SUBJECT: CORRECTION TO AMENDMENT NOS. 167 AND 157
(TAC NOS. M83068 AND M83069) (TS 92-01)

By letter dated April 28, 1993, the Commission issued Amendment No. 167 to Facility Operating License No. DPR-77 and Amendment No. 157 to Facility Operating License No. DPR-79 for the Sequoyah Nuclear Plant, Units 1 and 2, respectively. This was in response to your amendment request dated March 27, 1992.

FIGURE 5.6-3

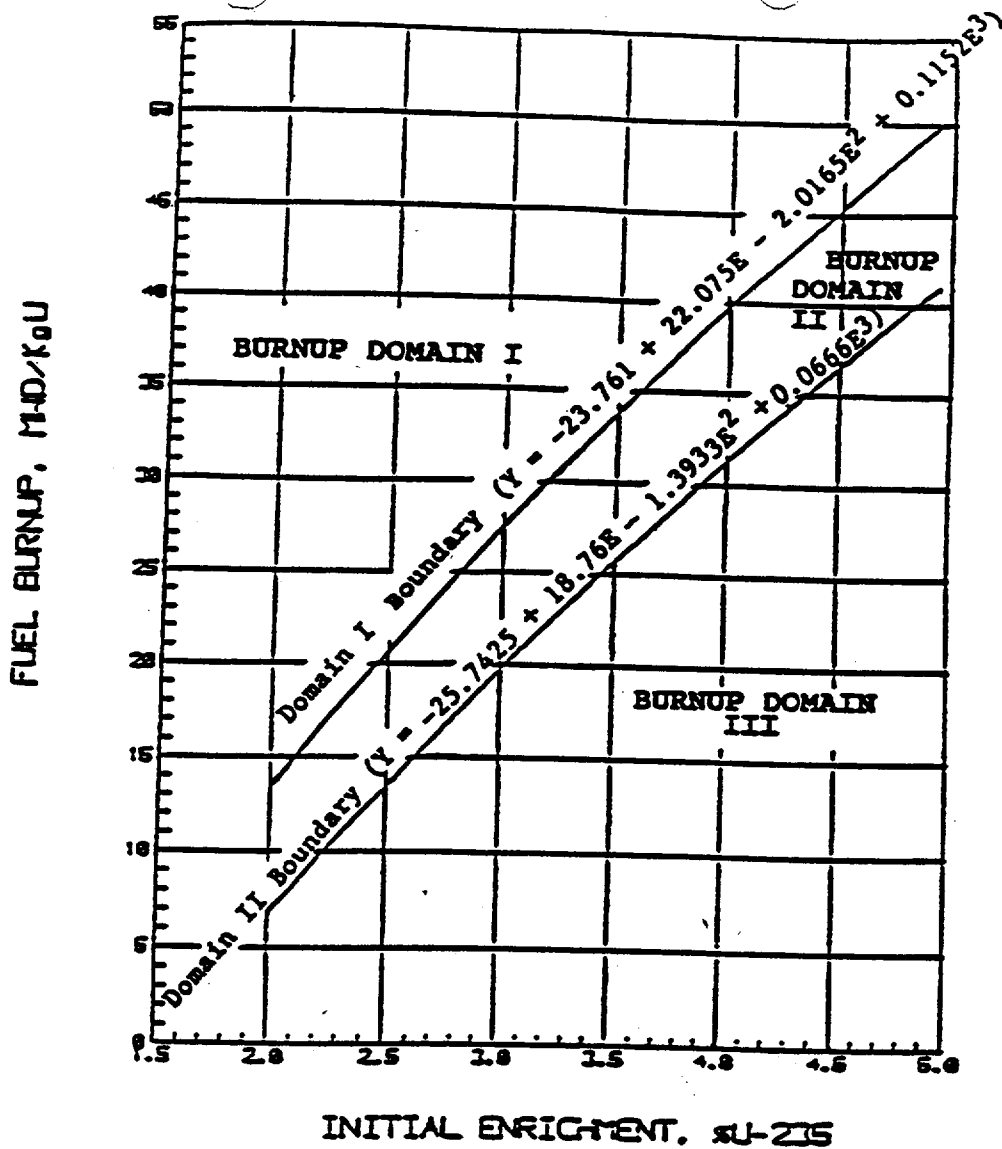
By letter dated September 26, 1994, you indicated that a typographical error had been found in Figure 5.6-3 of the submittal. The mathematical sign in front of the third term of the equation defining the Domain II Boundary fuel burn-up should be negative rather than positive. The correct equation is shown on Technical Specifications page 5-5, Design Features Section 5.6.1.1.c.3, which is the equation that was used to generate the curve in Figure 5.6-3. Enclosed is the corrected page to the Technical Specifications for Sequoyah Nuclear Plant Units 1 and 2.
